**Project: IEEE P802.15 Working Group for Wireless Personal Area Networks
(WPANs)**

Submission Title: comment resolution assignment

Comments for CIDs (v6)

Figure 23: Two Part Preamble

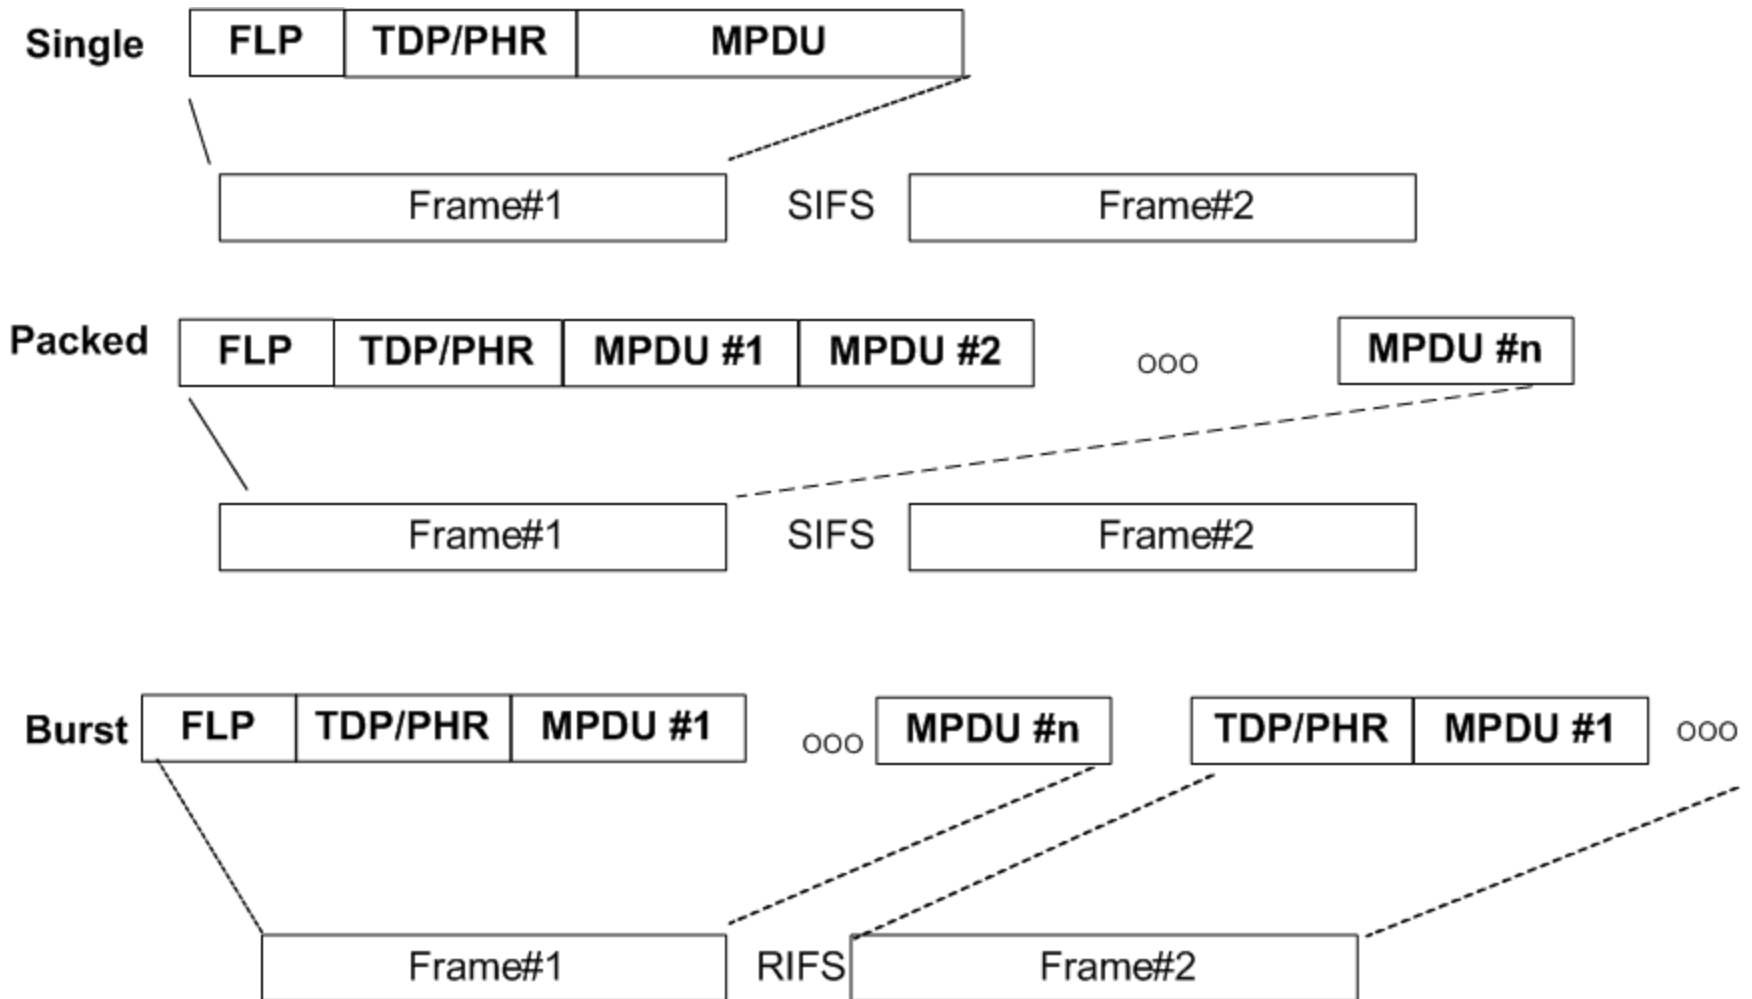
- In Figure 20, in Burst mode, there are two MAC PDU #n. These should be fixed.
- Figure 20 - Burst Mode - shows the same MAC PDU being transmitted twice, in both Frame #1 and #2. This figure does not align with the text
- (SY) In Burst mode, both packets are shown with the label "MAC PDU #n". I believe that the labels should be different

- Redraw the figure with correct PDU numbers.
- replace first MAC PDU #n with MAC PDU #1 and second MAC PDU #n with MAC PDU #2

Instruction to editor: Update Figure 23

Update Page 39, line 40 as follows:

- The standard defines one fast locking pattern (FLP) followed by choice of 4 topology dependent preamble (TDP) repetitions for the purposes of distinguishing different PHY topologies.

Update Page 39, line 46 as follows:

- After the fast locking pattern, 4 repetitions of one of four TDPs are sent.
